Proposed Surface Water Drainage Layout

ARUP Woodland Drive Medical Centre

Alternative Surface Water Scheme Option

SK-C-07_p1 Date: 17/04/2012 By: cpg

GRAVITY SW OUTFALL OPTION WITH ATTENUATION AND TRADITIONAL GULLEY RAINWATER COLLECTION.

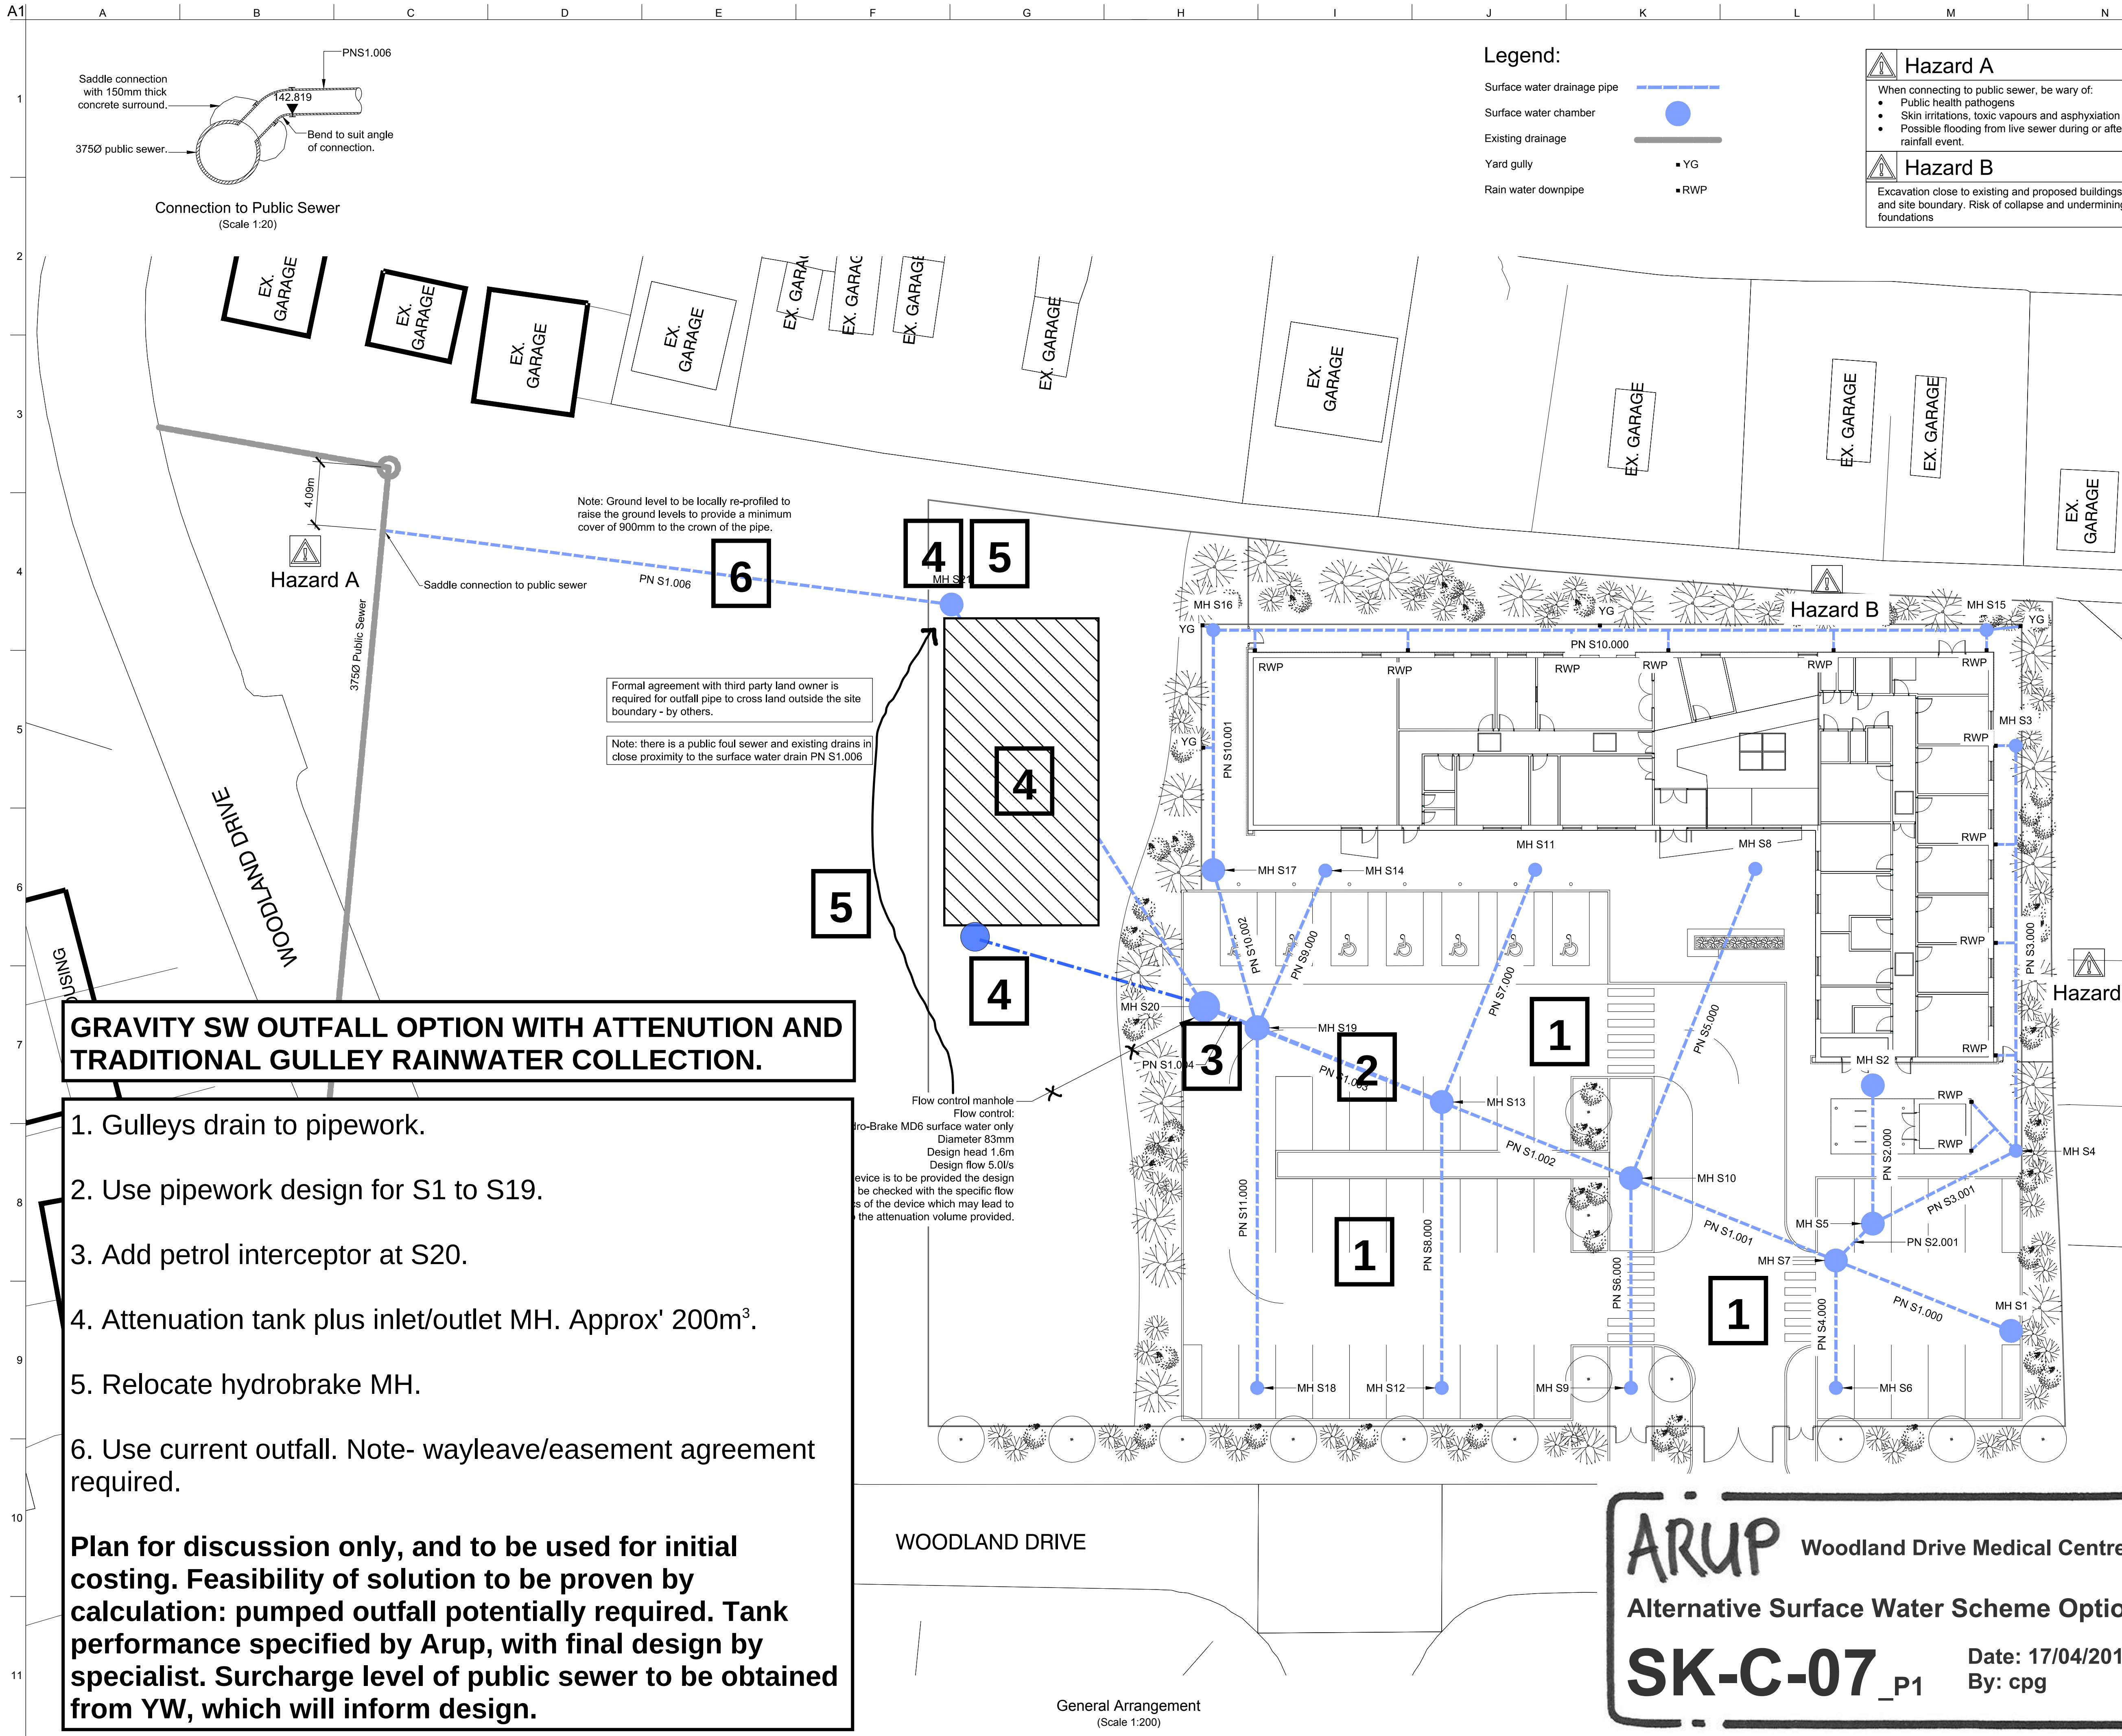
1. Gulleys drain to pipework.
2. Use pipework design for S1 to S19.
3. Add petrol interceptor at S20.
4. Attenuation tank plus inlet/outlet MH. Approx' 200m³.
5. Relocate hydrobrake MH.
6. Use current outfall. Note- wayleave/easement agreement required.

Plan for discussion only, and to be used for initial costing. Feasibility of solution to be proven by calculation: pumped outfall potentially required. Tank performance specified by Arup, with final design by specialist. Surcharge level of public sewer to be obtained from YW, which will inform design.
